Interactive comment on “Stream flow recession patterns can help unravel the role of climate and humans in landscape co-evolution” by P. W. Bogaart et al.

Received and published: 6 October 2015

Fig. 1.

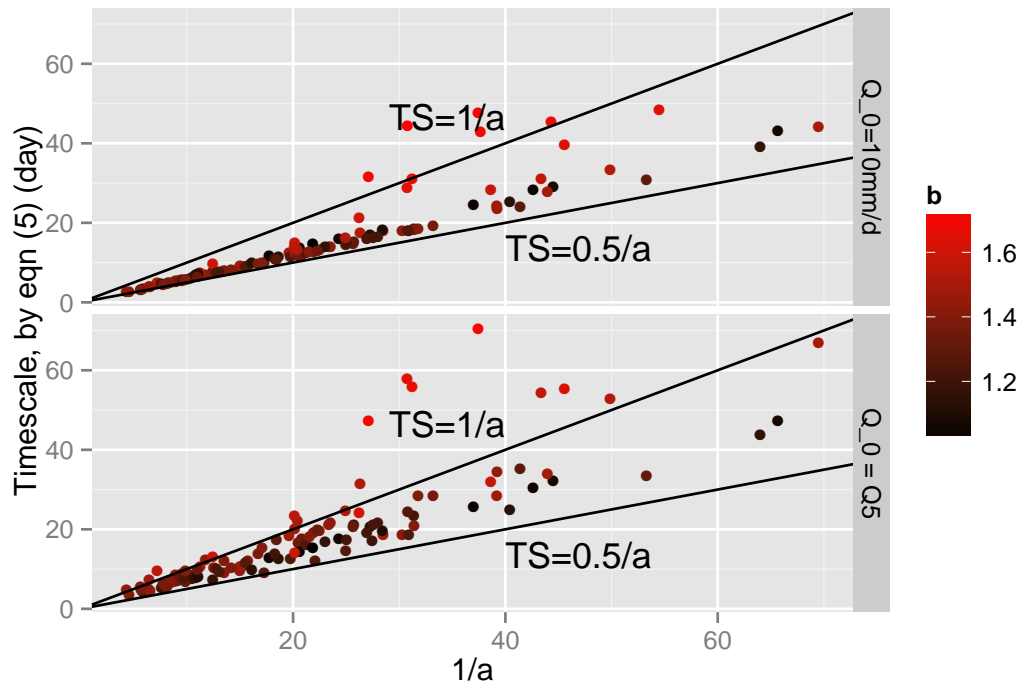
Issue 2: a is not, in general, a recession time scale. — We agree with Rupp and Woods that, in theory, neither a nor $1/a$ can be used as a time scale directly, because the effect of b and Q_0 in Eqn (5) cannot be ignored. However, in practice, this impact is limited. We used the two interpretations of Q_0 as explained above (i.e. either fixed 10 mm/day, or the 5% exceedance probability discharge per catchment) to compute the ‘proper’ time scale as per Eqn (5) and plotted them against $1/a$ (Figure 1 of this Reply). From these results, it is clear that proper time scale T and its approximation $1/a$ are strongly correlated. For $Q_0 = 10$ mm/d, 83% of the variance in T is explained by $1/a$ (linear regression; using the adjusted R^2 ; outliers removed) while for $Q_0 = Q_5$ this is 72%. However, Brutsaert-Nieber type of recession analysis traditionally focus on a and b , and therefore we decided to present a and $1/a$ rather than T .

Fig. 2.

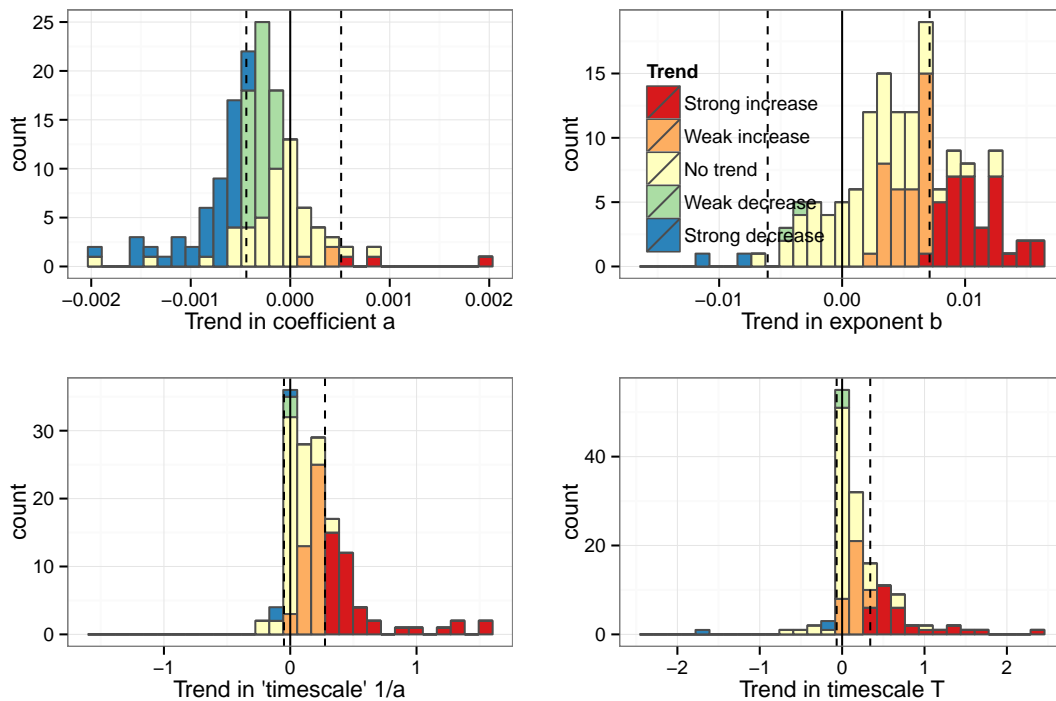
Issue 5: Trends in a cannot be understood without first accounting for the dependence on trends in b . — We agree that much of the trend in a is related to the trend in b . We do not claim that they change independently of each other. Nevertheless, our results that response time scales have been increasing over time still holds, even after correction for b . In Figure 2 of this Reply, we show trends in $1/a$ and T (using $Q_0 = 10$ mm/day to compute the latter). For $1/a$, 81 catchments show a significant increasing trend, and for T this is 65, suggesting that indeed part, but certainly not all of the trends in a or $1/a$ are caused by the trend in b .
